SUPPORT FOR THE AMENDMENT

Marked-Up Copy

Serial No: 09/803,103

FIG. 5

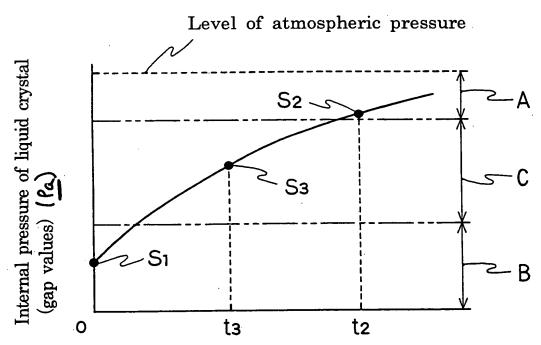
The Examiner has objected to Figure 5 for not containing units of time and pressure. Applicants respectfully submit herewith a proposed correction to Figure 5 indicating in red the appropriate units of time and pressure. Accordingly, withdrawal of this ground of objection is respectfully requested.
